INDESIT company

Model type:
MB40D2NFBSSP

Commercial code:
F029784

51522e0 Exploded views

NT007600

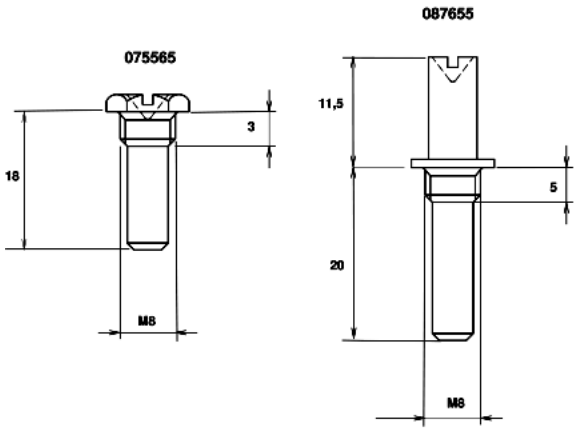
From the month of February 2002 (reg. No. 20207.0001) the Melano production has modified, on the electronic Ariston-2001 combinations with the display, the pivot of the hinge because the latter interfered with the wiring, which is lodged in the superior hinge, causing the breakage of the internal filament. Consequently, when it is necessary to substitute the wiring (081844) on the pre-modified models it will be also be necessary to change the pivot of the superior hinge with the new (see figure NT007500). When reassembling the wiring (081844) pay attention that it does not get trodden by the hinge and that it will be positioned around the pivot leaving it soft and not rigid (see figure NT007600).

087655 - SUPERIOR PIVOT HINGE M8X5 (H=20+11,5)

075565 - SUPERIOR PIVOT HINGE M8X3 (18+2,5)

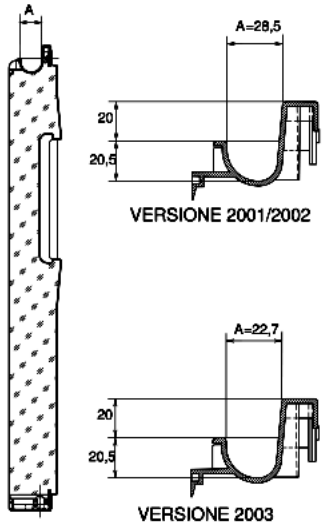
In March 2003 the Melano factory started using freezer doors with modified handle on the Ariston Opera-60 combined fridge-freezers (models MB-MBA-MBAA), in order to eliminate the problem of condensation.
The grip width has been reduced (from 28.5 to 22.7 mm) on these doors, as indicated by the dimension (A) in the figure (N1030059FIG1).
These freezer doors are already available as replacements and a coloured label on the packing distinguishes them from the previous ones. This will be done until stocks of premodification doors run out.
The codes of the freezer doors have not been changed:

In April / May 2003, production standardised the use of the inner door on all these doors, increasing the insulation efficiency by approx. 3%.
The door C00089881 offers approx. 10% more insulation than the door C00081997.

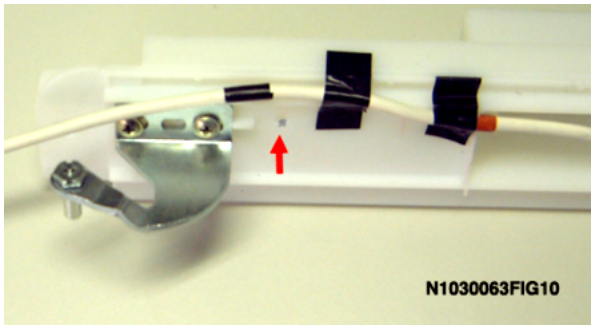
In October 2003 (serial no. 31028.0001) the Melano factory replaced the upper plastic hinge assembly on the Opera-60 fridge-freezers with display, in order to improve the fridge door support and prevent the cable connecting the two cards (power and display) from being damaged.
The new assembly provides for use of the upper hinge, chromed, with relative pin, and modified hinge cover (see fig.1-2).
The hinge assembly is reversible by rotating the single parts 180° and then refitting the pin (see fig.3).
Another two other tape reference marks (now three) have been placed on the card connection cable for correct installation on the panel base and fridge door in order to have the right flexibility during rotation. When the door is open the cable must never be strained.
The reference marks on the cable refer to right hand opening (see fig.4):
-Reference mark (A) indicates which end must be connected to the panel power card.

081644 - UPPER HINGE(M8) RH-LH CHROMED
075565 - UPPER HINGE PIN M8X3 (18+2.5)
097861 - UPPER HINGE COVER RH-LH ALUMINIUM
097862 - UPPER HINGE COVER RH-LH WHITE

097872 - PANEL/DISPLAY WIRING (3-MARKS)

081846 - UPPER HINGE (M8) RH WHITE (WIRING)
081847 - UPPER HINGE (M8) LH WHITE (WIRING)
081844 - PANEL WIRING (DISPLAY) KIT
081848 - UPPER HINGE COVER WHITE
082013 - UPPER HINGE COVER ALUMINIUM-METAL

N1030063FIG12

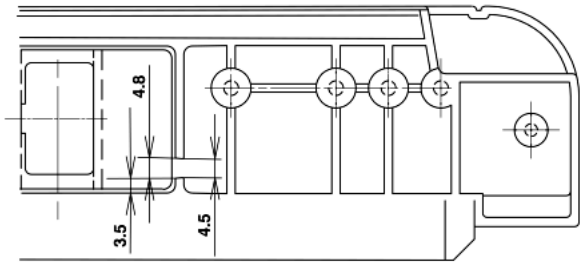
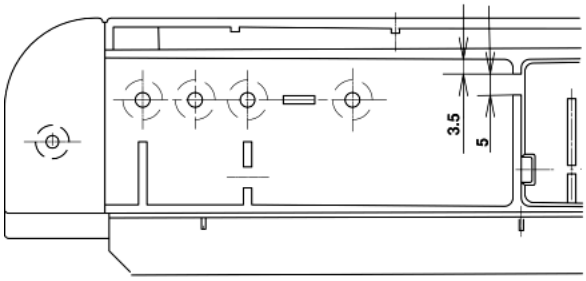
On the right hand bottom part of the cabinet panel base (hinge area) there is a slot (4.5/4.8) to be used for correct positioning of the cable (see fig.11-12).
Even the first cable seat on the upper head of the fridge door (hinge area, right side) has been modified, from 6x10 mm to 4x20 mm. This prevents the cable from moving when the door is opened/closed (see fig.13).
The fridge doors for models with display, currently managed as replacements, do not have the modification shown in fig.13; in this case the width of the cable (reference area C) must be increased using more adhesive tape until it is blocked in the first support seat (6x10 mm).

On premodification models, the new hinge assembly can only be used if the panel base is modified (see fig.11-12). On the left side the 5 mm slot is already present; whereas, for the fridge door, the width of the cable must be increased on models with right-hand opening (reference area C) as described above.
If the door opens on the left, proceed as described above (fig.7- 8-9-10).

N1030063FIG7

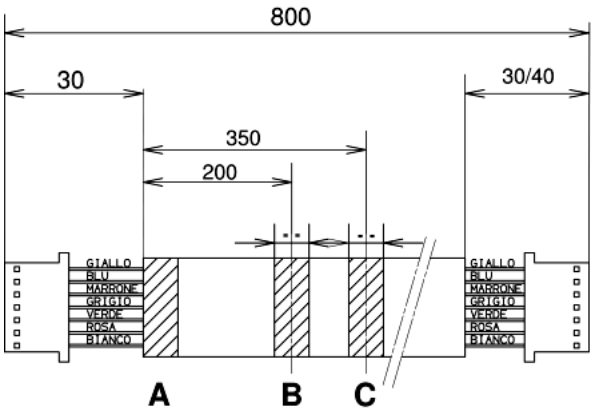
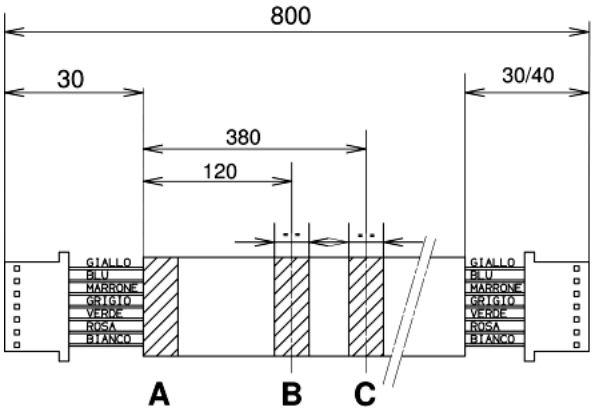
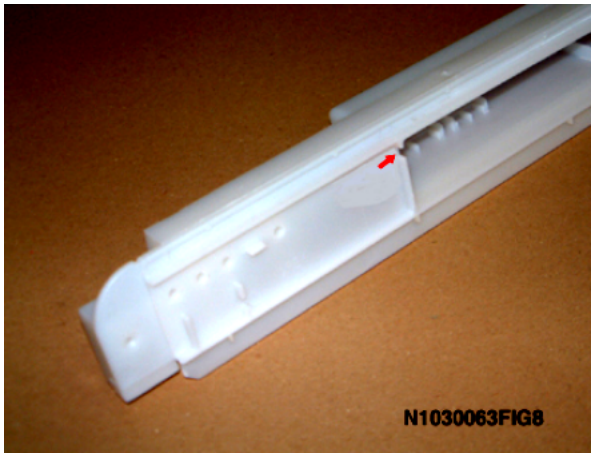
If the door opens on the left, these reference marks on the cable must be modified as shown in fig.7.
(A) has not been changed, whereas (B) has become 120 mm and (C) 380 mm. Colours other than black can be used so as not to confuse them.
Also, reference mark (B) must be fitted in the seat obtained on the panel (see fig.8), whereas the (C) must be fixed in the second tab from the left (see fig.9).
In the left-hand opening version, when tightening the fixing screw make sure the cable is not crushed by the panel. To avoid this, the cable should be fixed with adhesive tape to the vertical and horizontal ribbing, so that it passes inside the groove, thus avoiding the hole (see fig.10).

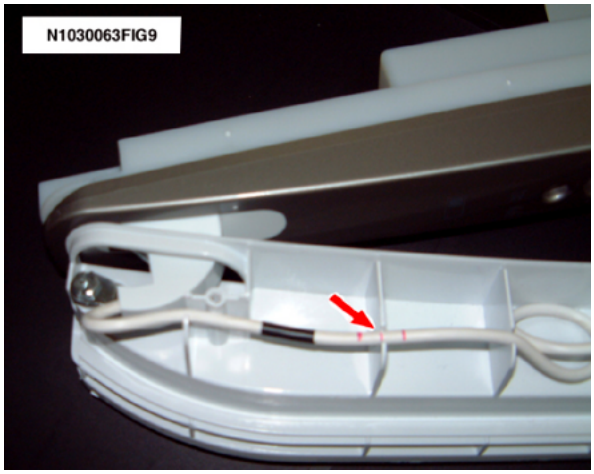
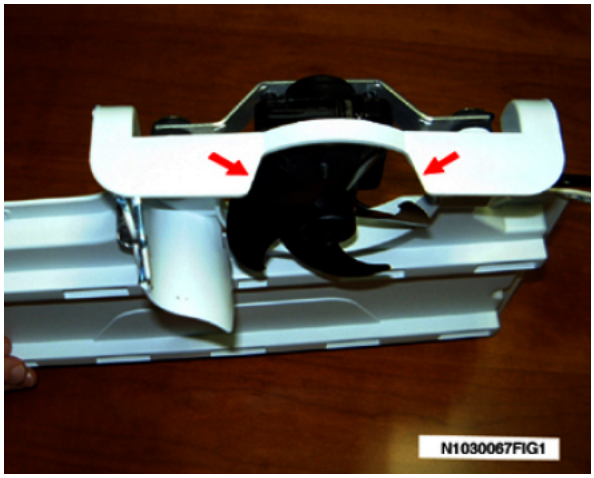
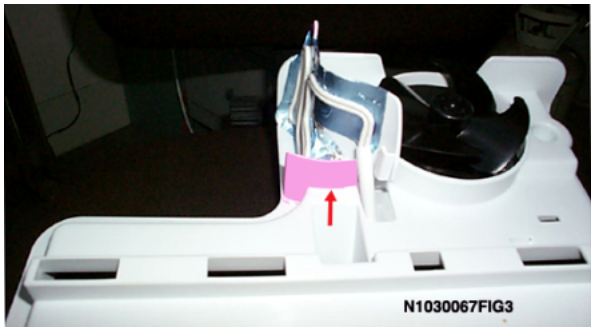
On Ariston and Indesit Opera60 Total No Frost fridge-freezers produced before August 2003, the freezer fan may stop due to ice

build-up (stalactites), activating the alarm.
The problem has been solved by emptying the conveyor (chamber separator) in the upper part to give the fan more space (see fig.1).

To solve the problem in products in use, an air conveyor kit (Sat code 094490), which also includes modifications to reduce dispersion air flow, has been introduced since 25/9/2003 (see fig.2) and 06/10/2003 (see fig.3).

KIT 094675 N1030068FIG3

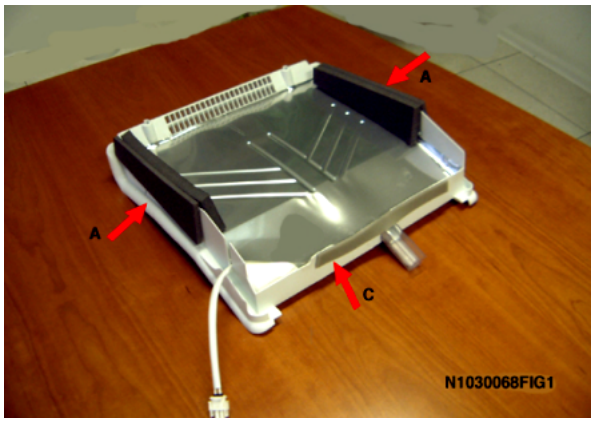
2) The lower vents on the multiflow have been closed from the inside (see fig.3/4-ref.A) and the outlet of those located in the curved area has been reduced (see fig3/4- ref.B). To solve the problem on products in use there are two spare part kits: 094675 for the version with three outlets, and 094737 for that with four.

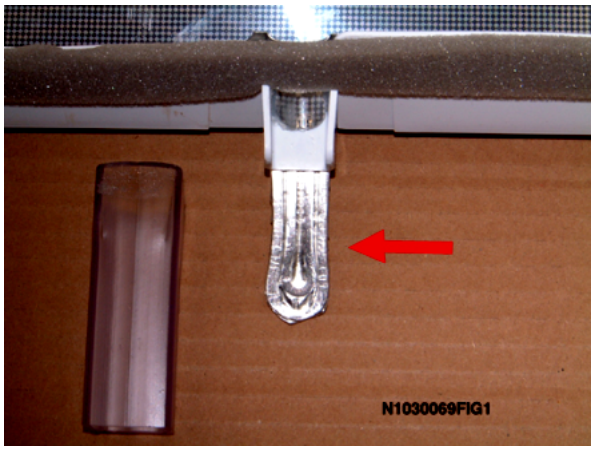
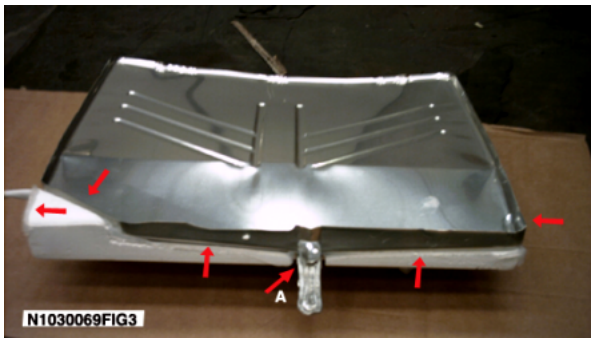
On Ariston and Indesit Opera60 Total No Frost fridge- freezers produced before June 2003, the freezer separator drip hole may be obstructed due to ice build-up.

The problem has been solved by fitting a double filament resistance at the end part, which can be seen by removing the rubber protection. (see fig. 1). The resistance is glued to the drip (see fig. 2).
Freezer separator Sat code 094485, complete with modified resistance, is managed as a replacement to solve the problem on products in use.

If the 40W resistance needs replacing it will be necessary to restore the sealing, located in the hole area, using silicone (see fig3 - ref A).
Also, to protect the separator from possible water penetration, silicone is used to protect the drip with polystyrene insulation at the back, and also the right corner, relevant to the wiring outlet is protected with silicone in the upper part.

N1030079FIG2

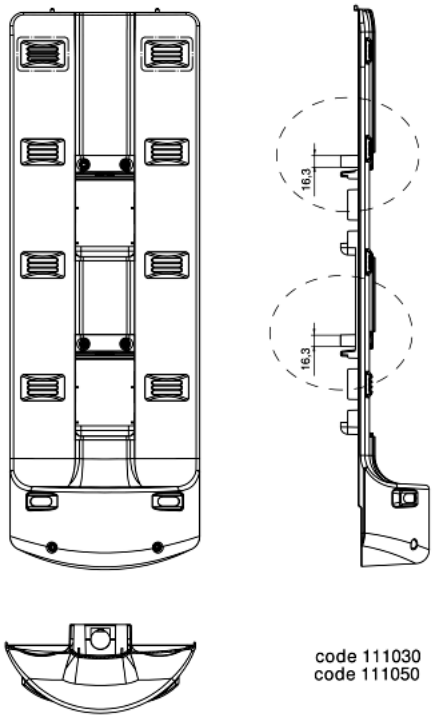
In June 2004 (serial no. 40604.0001), the Melano factory modified the multiflow fixing system to the shell on Ariston and Indesit Opera-60 Total No Frost fridge-freezers.
The inner wall of premodification models featured four square marks (20x20) in the central area for fixing the multiflow cover. The four marks have been eliminated and the wall only features the position for the holes.
Furthermore, the head of the four pins that house the fixing screws on the multiflow cover have been modified. Premodification items ended with an external diameter of 9 mm, whereas the current version has a diameter of 16.3 mm (see figures N1030079FIG1 and FIG2).
The new multiflow cover can be mounted on premodification models but not vice versa, paying attention not to overtighten the screws as the pins may break. If necessary, bush 039567 can be used as stopper.
The multiflow cover is managed as Kit to solve the problem, on products in use, of the formation of condensation on the vegetable basket due to the inflow of cold air from the freezer (see note N1030068).

111030 - 4-way multiflow cover KIT (serial no. 40604.0001)

111050 - 3-way multiflow cover KIT (serial no. 40717.0001).

094737 - 4-way multiflow cover KIT
094675 - 3-way multiflow cover KIT

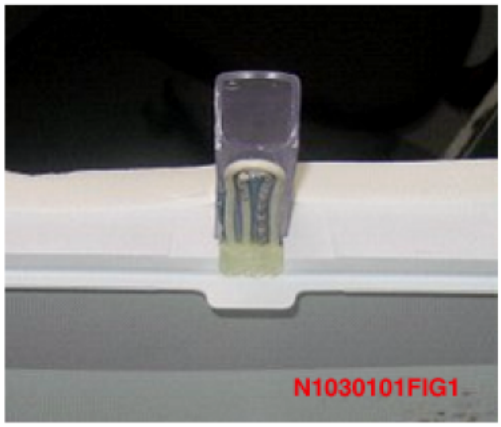
In October 2004, the Melano factory modified the freezer evaporator and return tube on Ariston and Indesit Opera-60 total no frost fridge-freezers, in order to improve the connection.
Now the return tube is straight (outer diameter 6 mm), whereas previously it had a socket end 15 mm long (outer diameter 6.35 mm).
Before the modification, the coil tube on the freezer evaporator (outer diameter 8 mm) was straight, now it has a tapered end section 15 mm long (outer diameter 7.6 / inner 6.2 mm) to insert the return tube.
If the evaporator needs replacing, it will be necessary to connect it with a Lokring connector 7.5/6 NRAL50 (058213) or 7.5/6NRMS00 (058203).

If tightness is lost when the ring is removed, it will be necessary to use connector 8/6 NRAL50 (058214) or 8/6 NRNS00 (042050).

The new freezer evaportor can be fitted on premodification appliances, but once the ring is removed, the 6 mm outer diameter must be restored on the return tube (check that it is long enough to be able to use the pliers to connect the 7.5/6 ring).

113845 - NOFROST FREEZER EVAPORATOR ASSEMBLY R600/R134a

094667 - NOFROST FREEZER EVAPORATOR ASSEMBLY R600/R134a
